**STATE OF VERMONT
PUBLIC UTILITY COMMISSION**

Case No. 21-2939-NMP

**NEIGHBOR INTERVENORS' COMMENTS ON PETITIONER'S
REQUEST FOR A WAIVER OF RULE 5.108(B)**

July 8, 2022

Figure 1

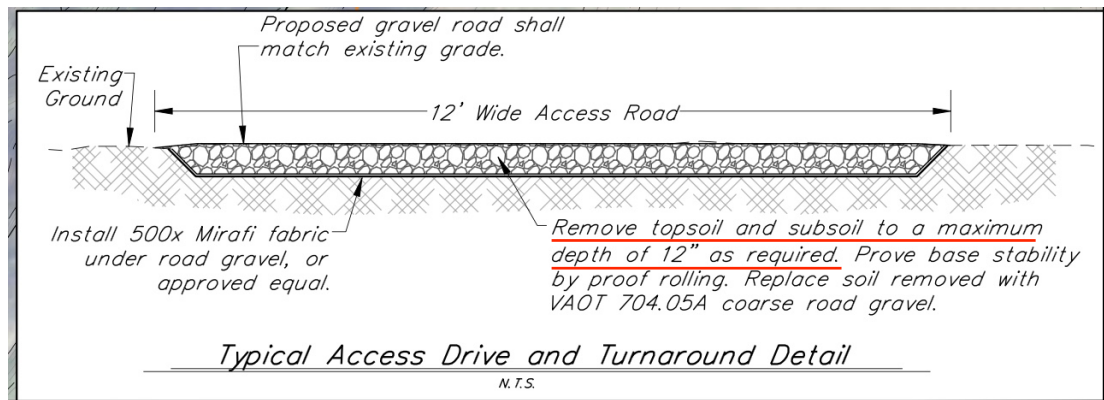
In Part I of these Comments, Landowners request that the reader pretend the project site is flat and that the Access Road Cross Section in the Site Plan (Figure 1) is a typical cross section of the road.

Note that in Figure 1, PAS is removed to a maximum depth of 12 inches. If the excavation turns out to be less than 12 inches, the volume of the PAS would (of course) be less than 4800 cubic feet. In order for the PAS to fit in the 10 ft x 60 ft PAS Storage Area with a 2:1 slope embankment, the depth of the 12 ft wide road excavation would have to be less than 2 inches. If the excavation of PAS is 2 inches or deeper, the PAS Storage Area is undersized.

Now, in Part II, the Thought Experiment is replaced by Reality. The Access Road is not on flat land and the cross section in the Site Plan (Figure 1) is very misleading. The proposed road is actually on very steep slopes and it will require extensive cutting and filling and ditching.

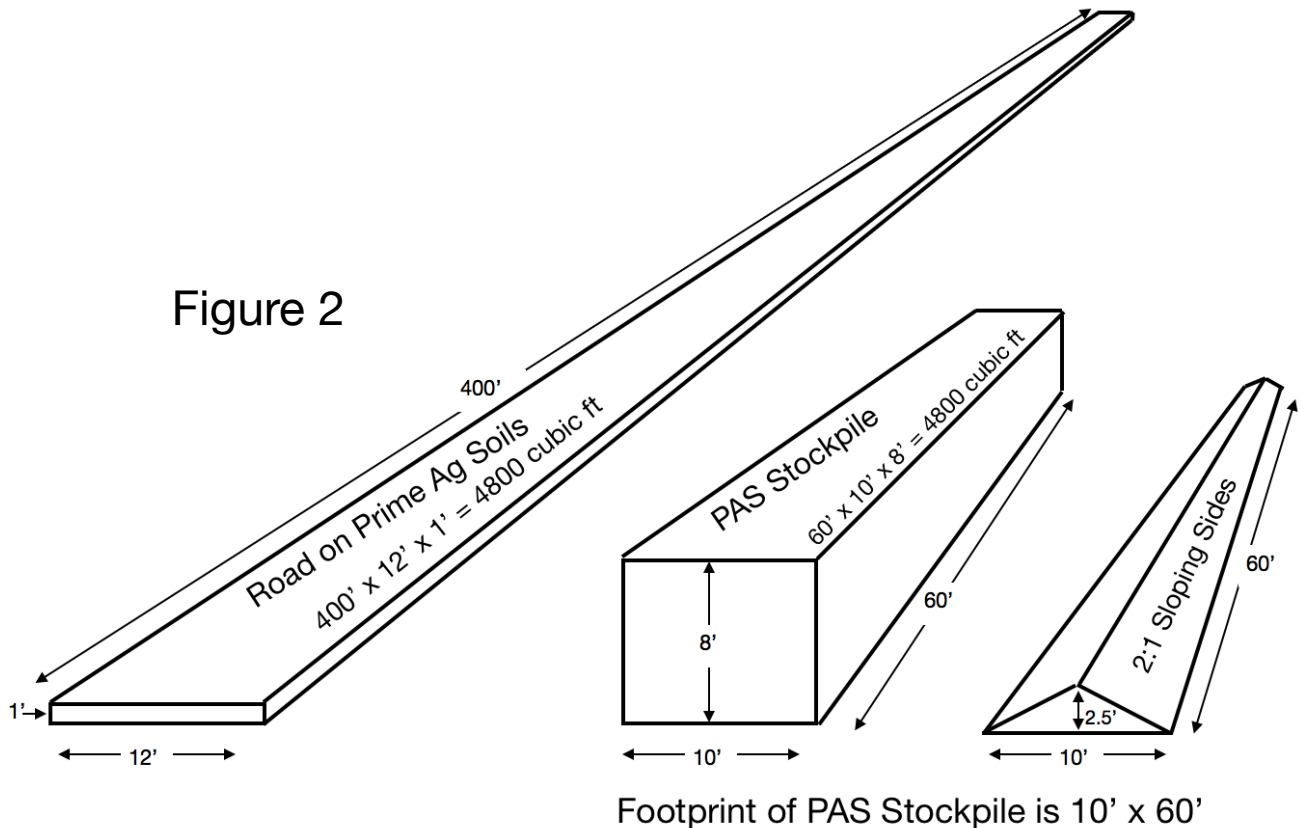
The Site Plan (see Figure 3) shows that a 400 ft stretch of the Access Road is on Buckland Prime Agricultural Soils (PAS). If the PAS were scooped out of the road bed as described in Figure 1, the volume of the PAS would be 4800 cubic feet (see Figure 2).

As can be seen in Figure 2, the amount of PAS removed from the Access Road would fill a rectangular solid measuring 10 ft wide, 8 ft high, and 60 ft long. Of course, soil embankments must be sloped. An embankment with a 2:1 slope is depicted in Figure 2, and its capacity on a 10' x 60 ft footprint is less than 750 cubic ft.

Figure 3 is a detail from the Site Plan and it shows the part of the Access Road that is on PAS.

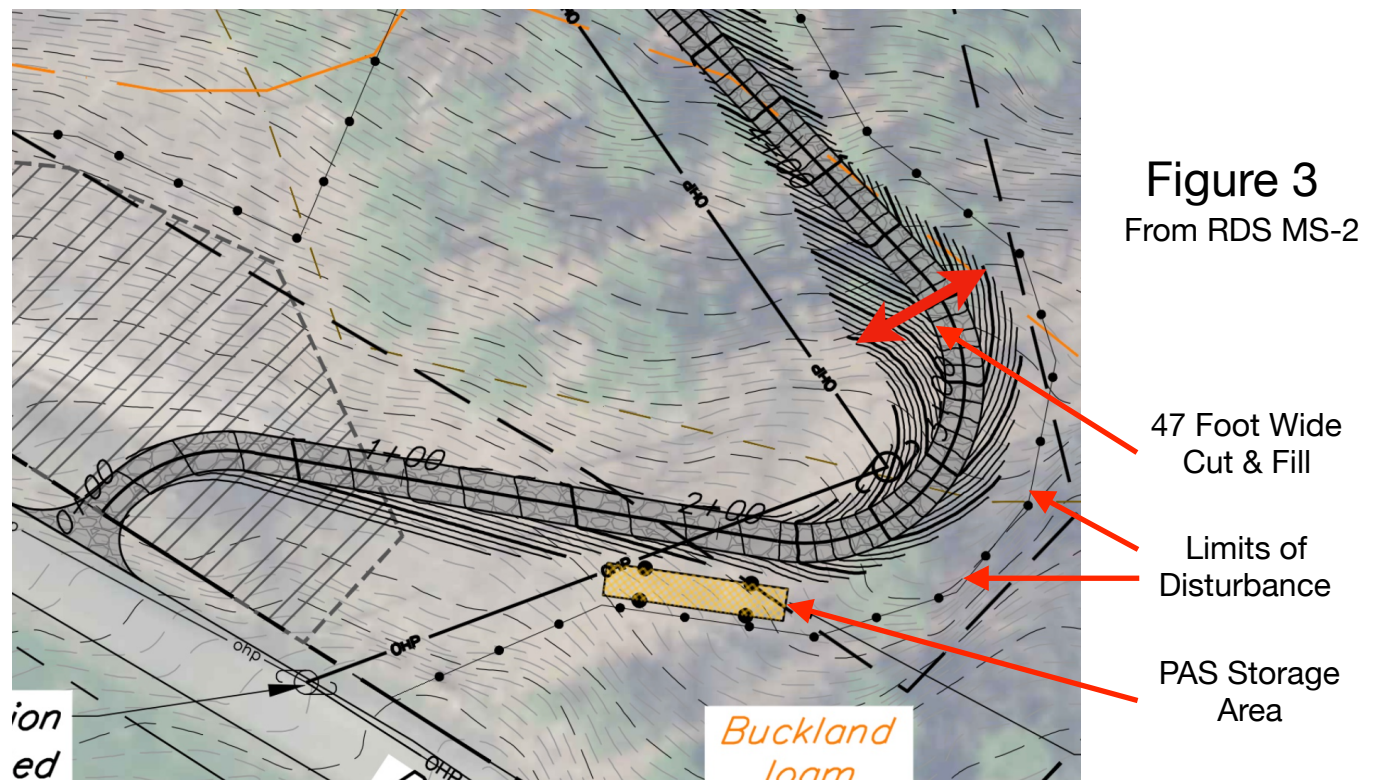
Note that the cut & fill is up to 47 ft wide at the double-headed red arrow. The Agency of

In Part I of these Comments, Landowners demonstrated that if the PAS was excavated **just** 2 inches deep over the length and width of **just** the 12 ft wide roadbed, the PAS Storage Area would be undersized. Now, in Part II it is clear that the depth of excavation of PAS will be at least 20 inches (in a best case scenario) and the area of excavation will be significantly wider than the 12 ft roadbed (up to 47 ft). The PAS Stockpile Area is likely undersized by two orders of magnitude.

The location of the PAS Stockpile Area is constrained by its proximity to the Limits of Disturbance (Figure 3). There are steep slopes between the Stockpile and the town road. The Stockpile Area cannot be enlarged, by orders of magnitude, in its current location to contain the excavated PAS. Any cure for the deficient PAS Stockpile Area will create a Major Amendment. Any cure for the inability to properly reclaim PAS will require rerouting the Access Road off of the steep PAS, and that will also create a Major Amendment.
